UNITED STATES PATENT AND TRADEMARK OFFICE

APPLICATION NO.	FILING DATE	FIRST NAMED INVENTOR	ATTORNEY DOCKET NO.	CONFIRMATION NO.
10/583,021	07/27/2007	Sandra Ketterl	30051/41060	6967
4743	7590	08/03/2009	EXAMINER	
MARSHALL, GERSTEIN & BORUN LLP			ALTUN, NURI B	
233 SOUTH WACKER DRIVE				
6300 SEARS TOWER			ART UNIT	PAPER NUMBER
CHICAGO, IL 60606-6357			3657	
			MAIL DATE	DELIVERY MODE
			08/03/2009	PAPER

Office Action Summary	Application No.	Applicant(s)
	10/583,021	KETTERL ET AL.
	Examiner	Art Unit
	Nuri Boran ALTUN	3657

DETAILED ACTION

Fig. A

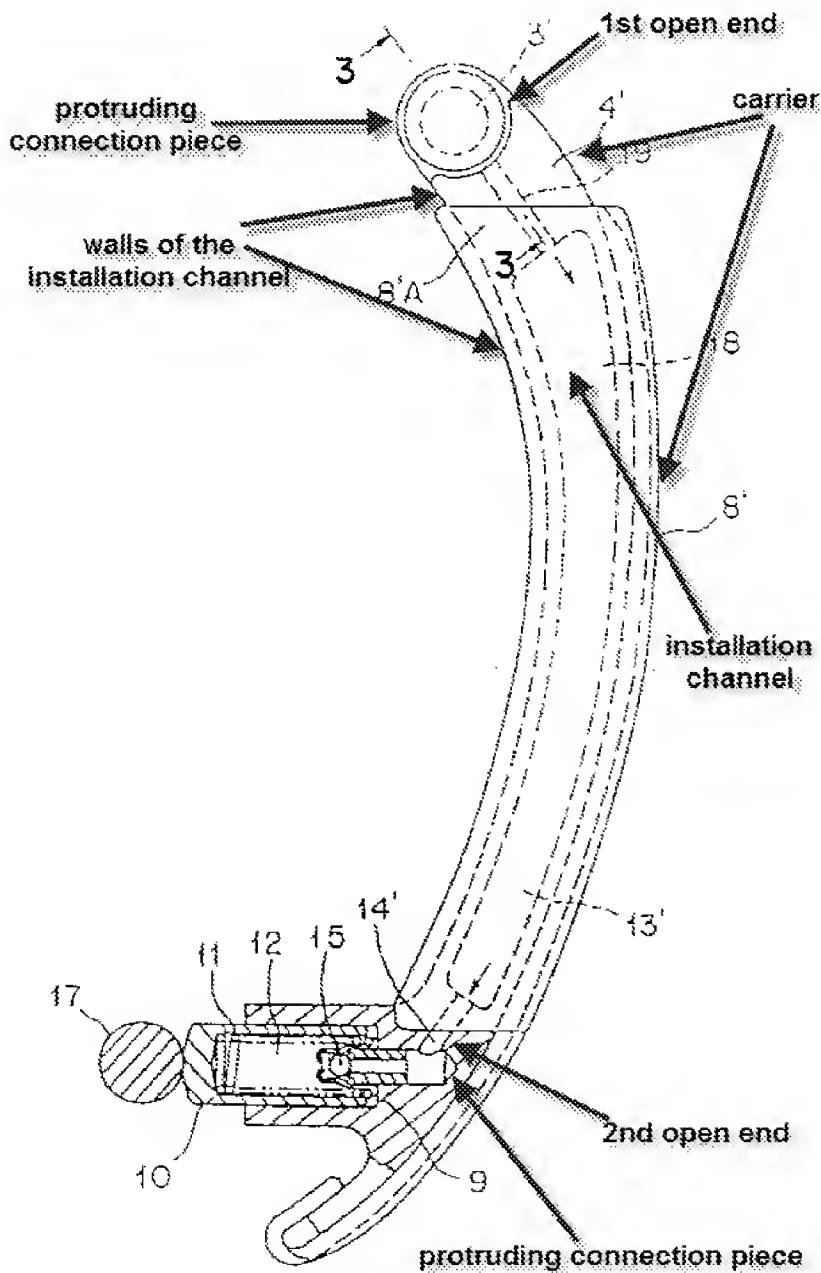
As per claim 1, Inoue et al. teach a device for an internal combustion engine having a tension or guide rail (1) for a flexible drive means (4) and an additional component (10) interacting with the internal combustion engine, the tension or guide rail comprising a carrier body (4' and 8'), a guide track (8') which can be pressed onto and is in contact with the flexible drive means (see Figs. 1 and 2) and an installation channel (18) which acts independently from the guide track, and which is formed as a circumferential surface and with a first open end and a second open end (see Fig. A), the walls of the installation channel being formed by the carrier body (see Figs. 2-4 and

see Fig. A below), the first open end and the second open end being arranged on opposite face-side ends of the tension or guide rail (see Figs. 3 and 4 and also see Fig. A) and at least some sections of the additional component (10) extending through the installation channel (see Fig. 2).

As per claim 5, Inoue et al. teach the first open end is formed with a protruding connection piece (4') (see Fig. A).

As per claim 12, Inoue et al. teach the second open end is formed with a protruding connection piece (see Fig. A).

The applicant first argues, "the examiner's interpretation of Inoue et al. reference is too broad and based on hindsight reasoning. That is, the first embodiment described in Inoue et al. shows a channel formed and closed on its circumferential surface, wherein the walls of the installation channel are not only formed by the carrier body, but also by the tensioning shoe." The examiner notes that the walls of the installation channel are formed by the carrier body as seen in Figs. 2-4 and Fig. A. The walls of the installation channel being formed also by the tensioning shoe does not preclude the

Inoue et al. reference from anticipating the limitation “the walls of the installation channel are formed by the carrier body.” Therefore, the interpretation of the reference is not broad by any means. Further, only one embodiment of Inoue et al. (Figs. 2-4 of Inoue et al.) is used to reject claim 1, the rejection is made under 35 U.S.C. 102(b). No different embodiments or references are combined; therefore, the interpretation is not based on hindsight reasoning.

Fig. C

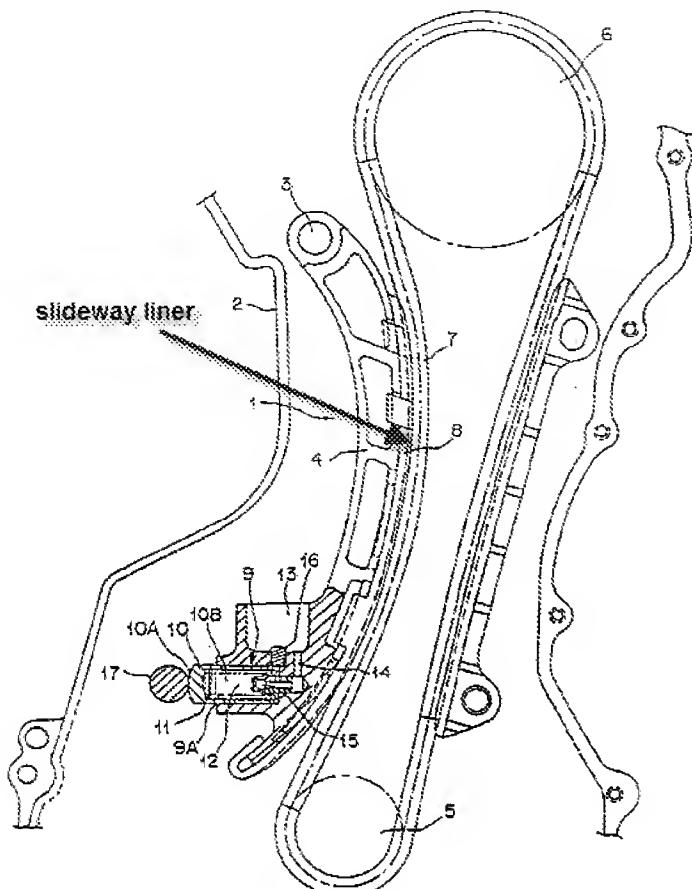
As per claim 6 Inoue et al. teach the tension or guide rail comprises a slideway liner (8) which is joined to the carrier body and forms the guide track (col.7, lines 47-48) and see Fig. C below).
